In respect of
**Cefn Road Solar Farm,
WREXHAM**

Construction Traffic Management Plan

Technical Note 01: Response to Wrexham County Borough Council Comments

TITLE:
Construction Traffic Route
Plan

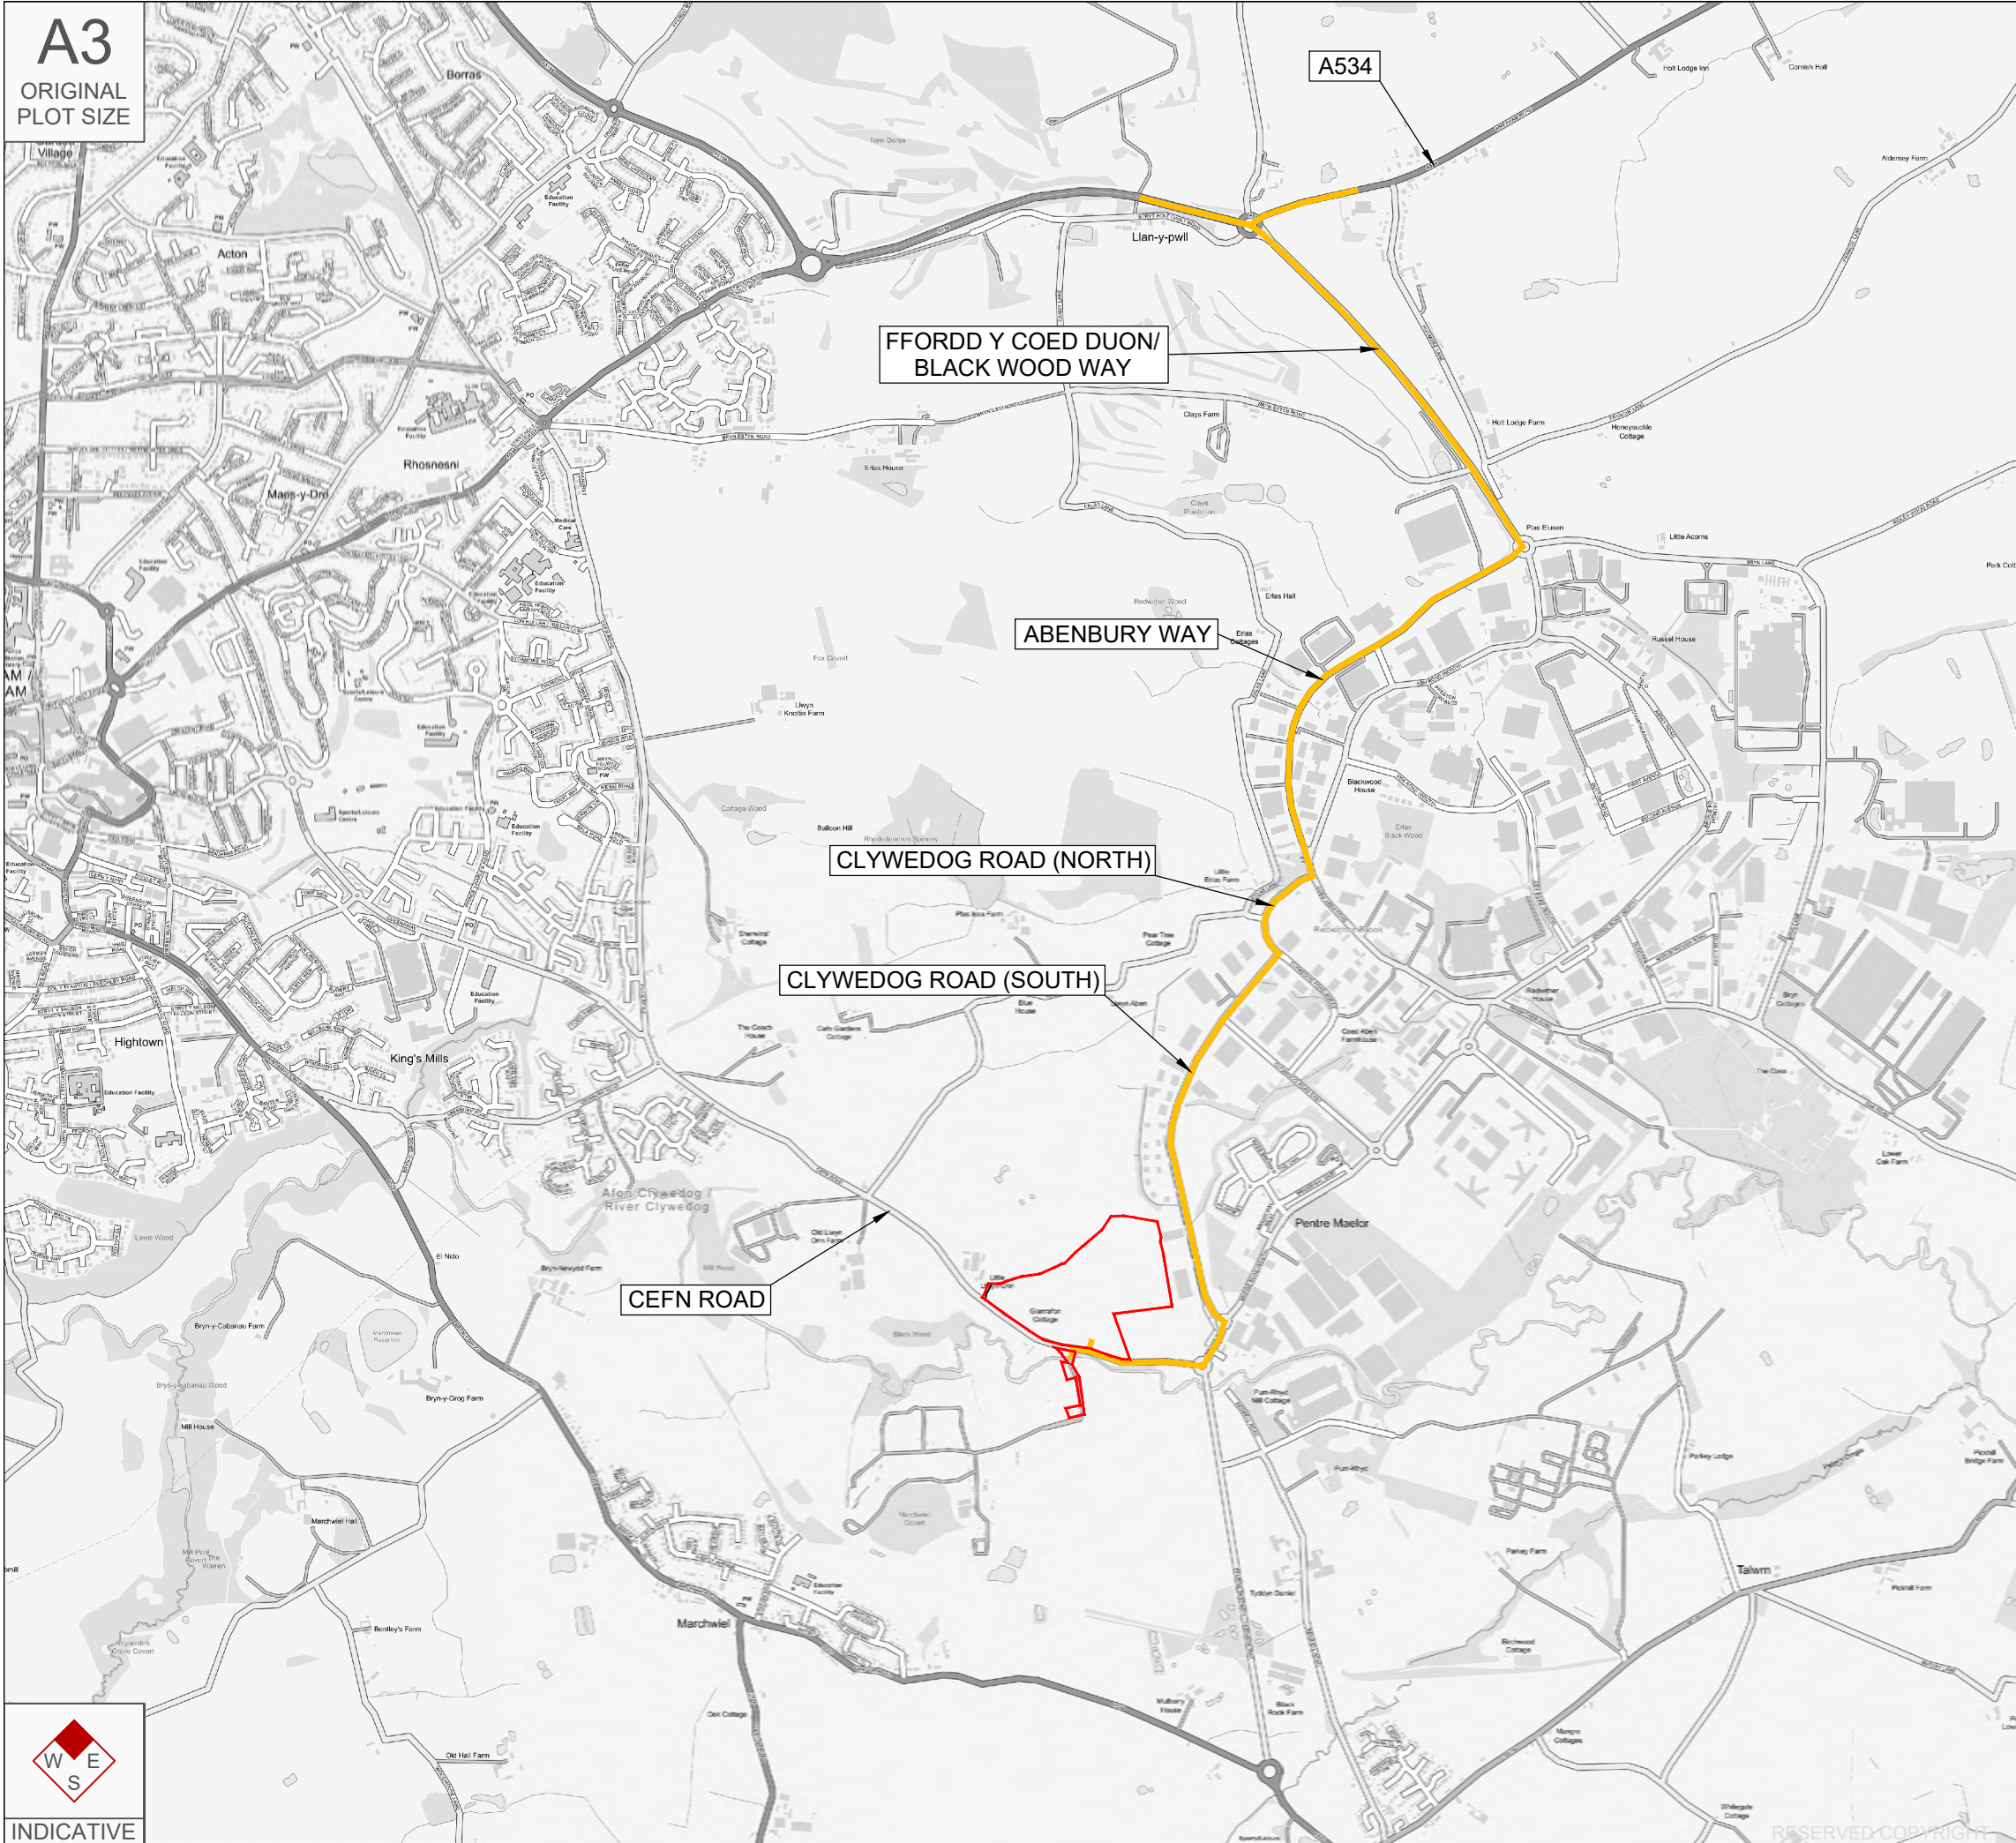
Comment 4: *"The submitted layout plan appears to indicate a potential secondary access located on Clywedog Road South. I assume that this is the existing gated field access in this location.*

The submitted Redline Boundary Plan (Drg. No. CE/321/06) does not appear to include the land required to utilise this access. I would recommend that further details are provided in respect of the proposed use of this access."

- 1.10 Clywedog Road will be used as part of the route that construction vehicles will use to access the Site access on Cefn Road. This is shown in Figure 3.1 of the CTMP. However, there will be no access into the Site directly from Clywedog Road. The only access will be from Cefn Road.

Proposed Site Access Arrangement

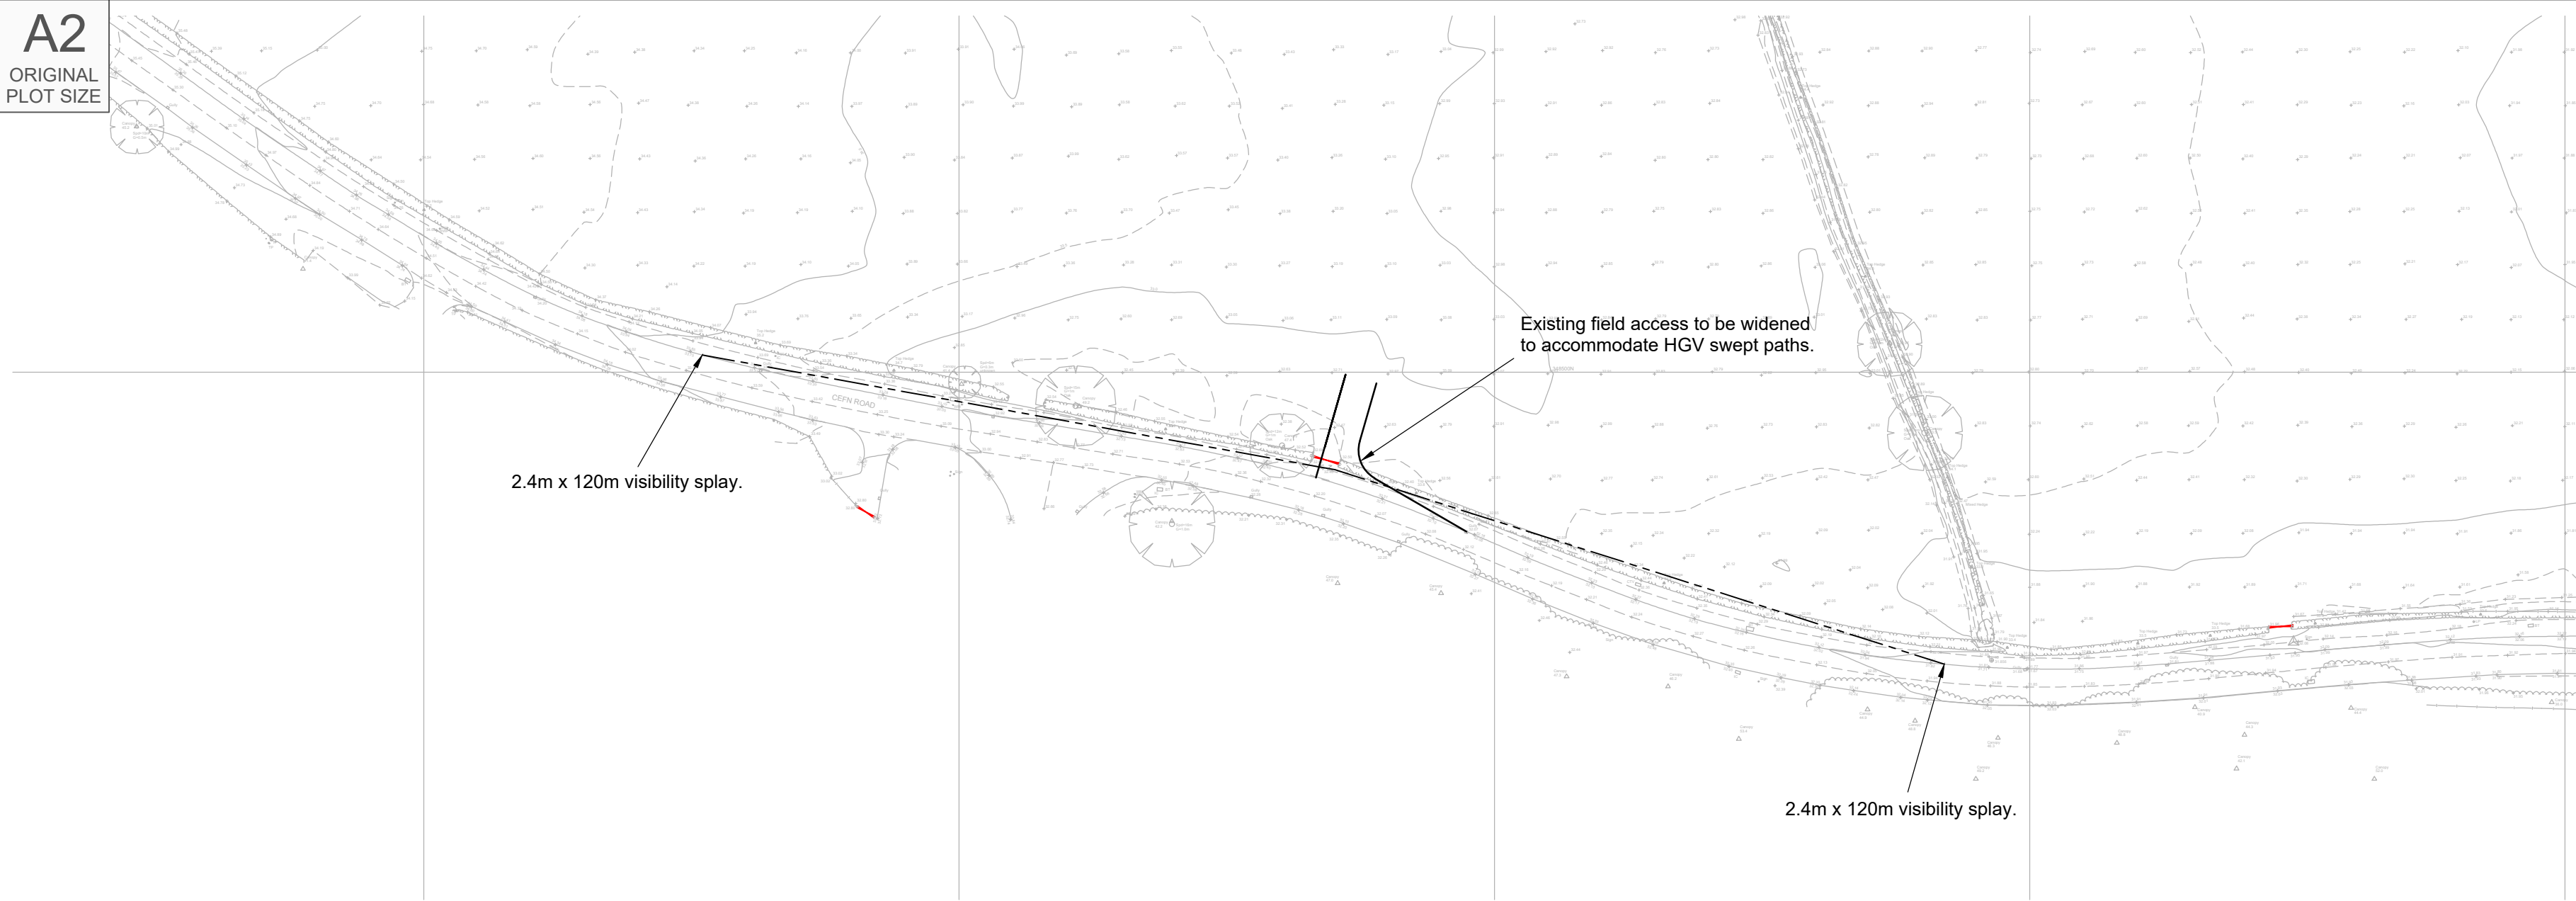
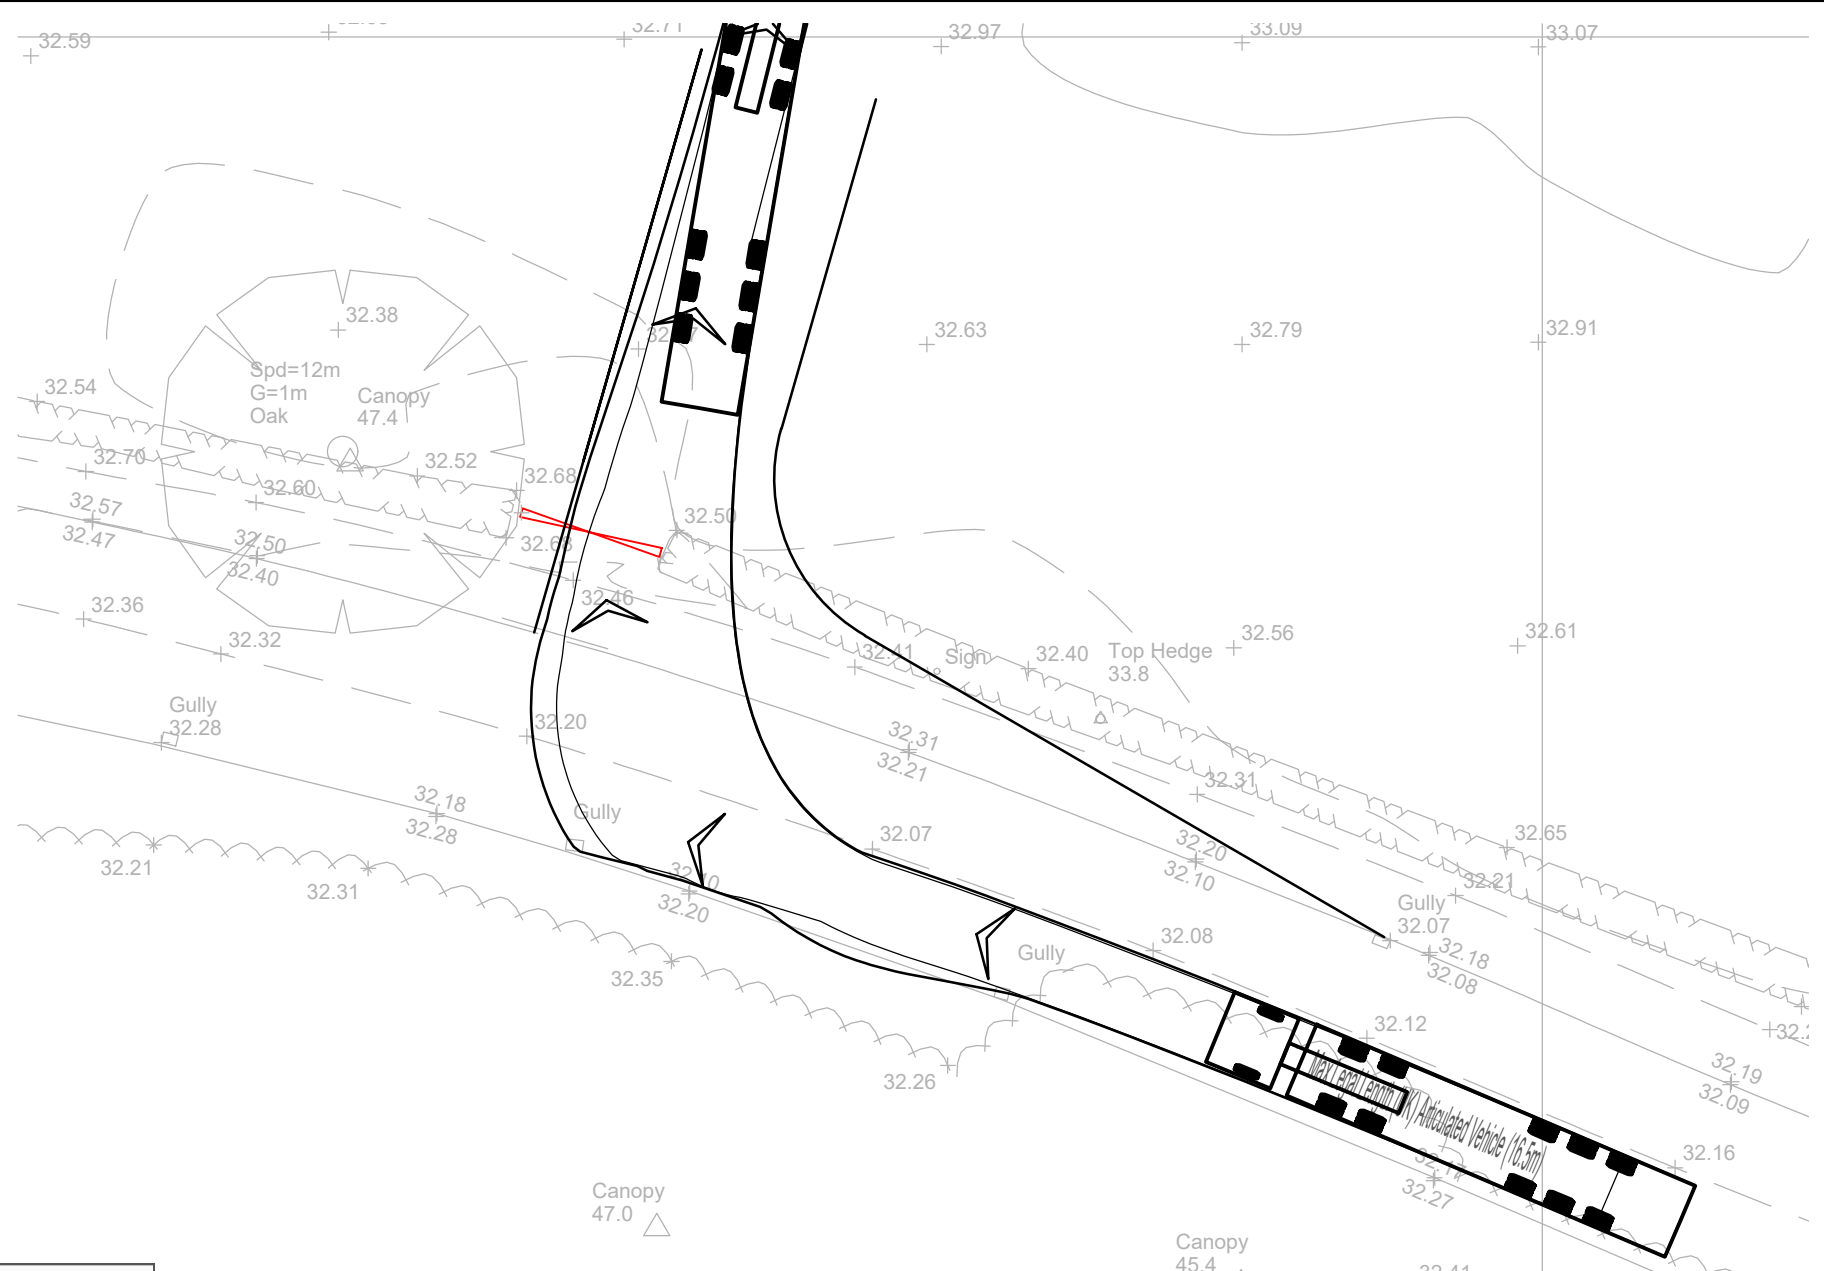
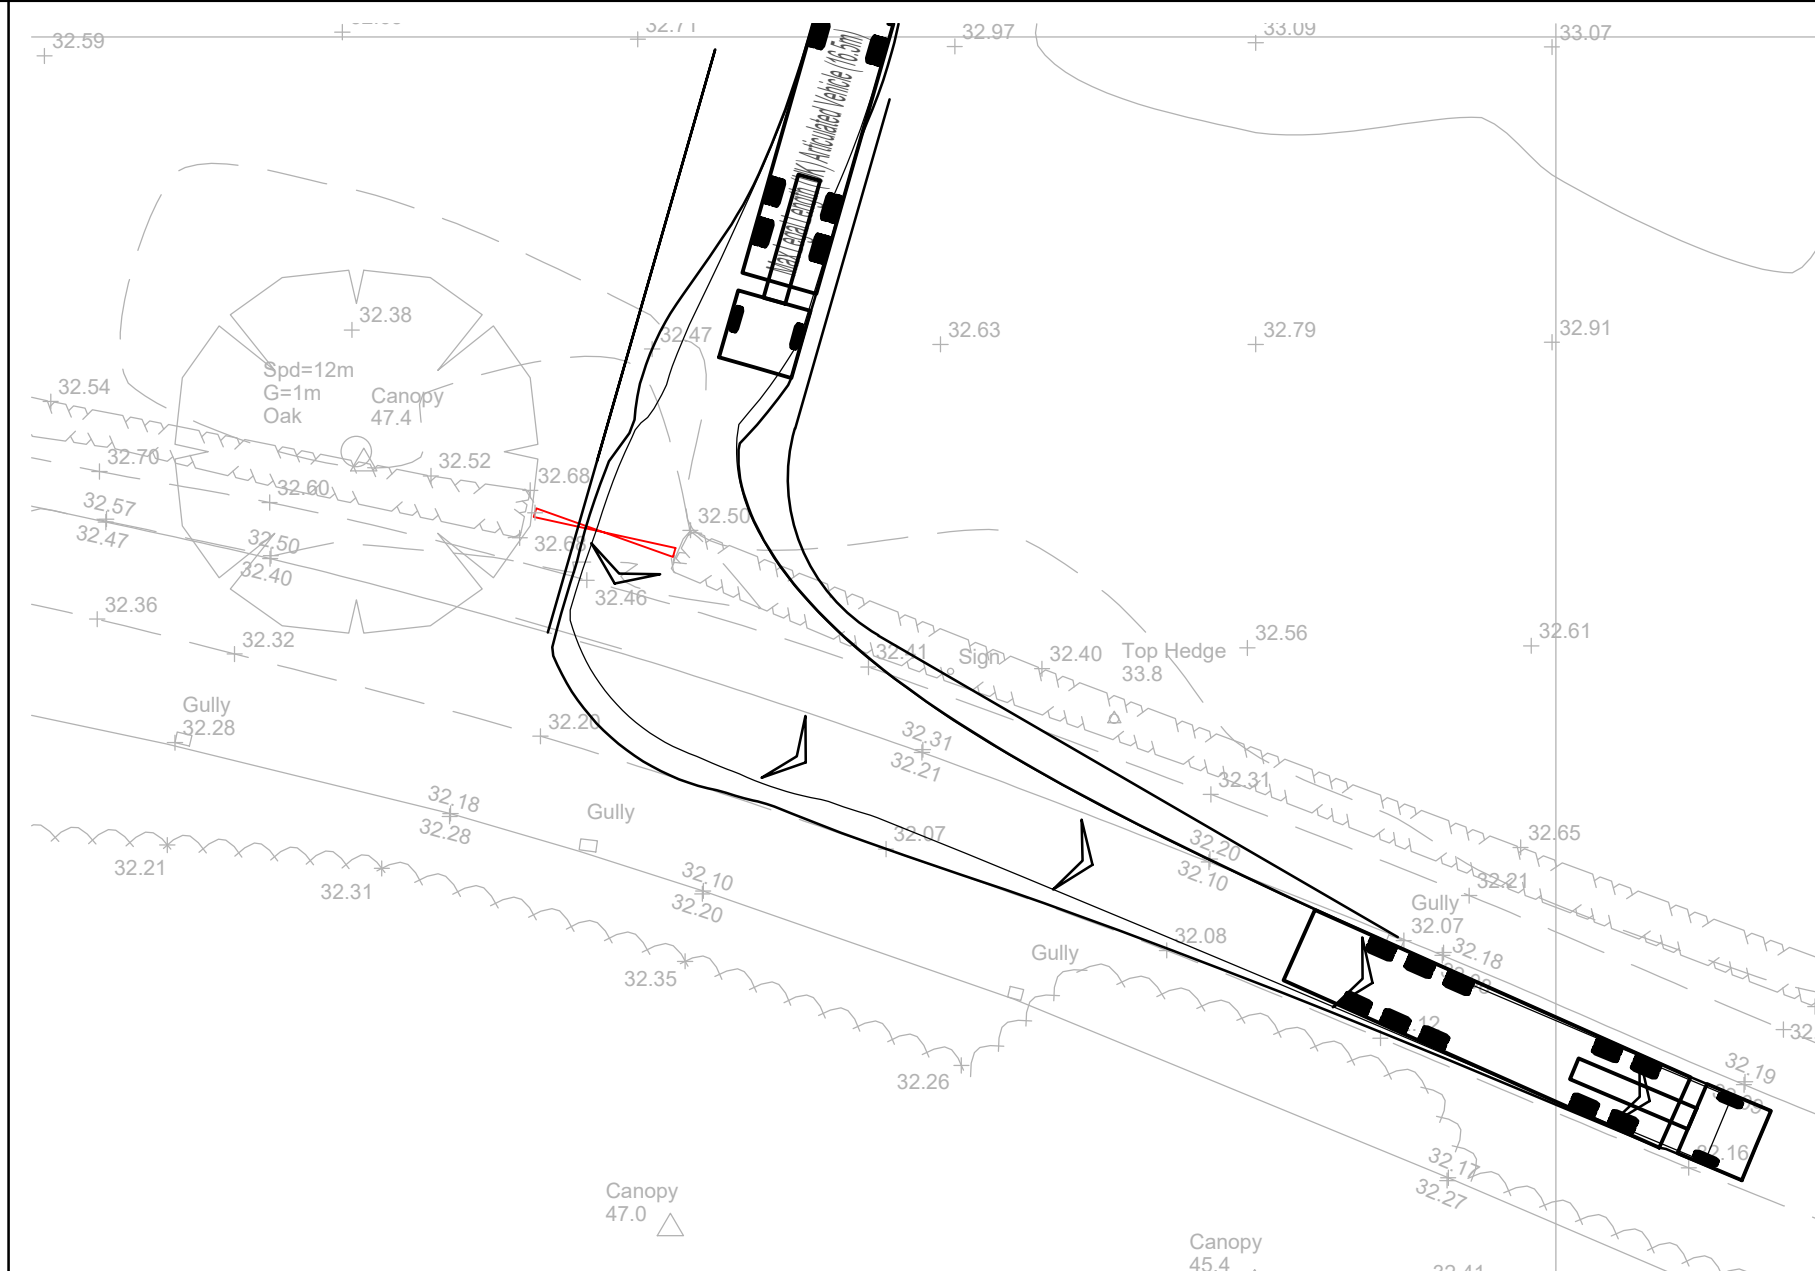
Comment 1: *"Cefn Road is a rural, classified road subject to a 40mph speed limit. Any proposed / existing access in this location would normally be required to provide visibility splays of 2.4 x 120m in both directions measured to the nearside edge of the adjoining highway."*

- 1.4 Drawing SK01, included in Appendix B of the CTMP, demonstrates that visibility splays of 2.4 x 120m, are achievable in both directions when measured to the nearside edge of the adjoining highway. The visibility splays will be kept clear throughout the construction period.
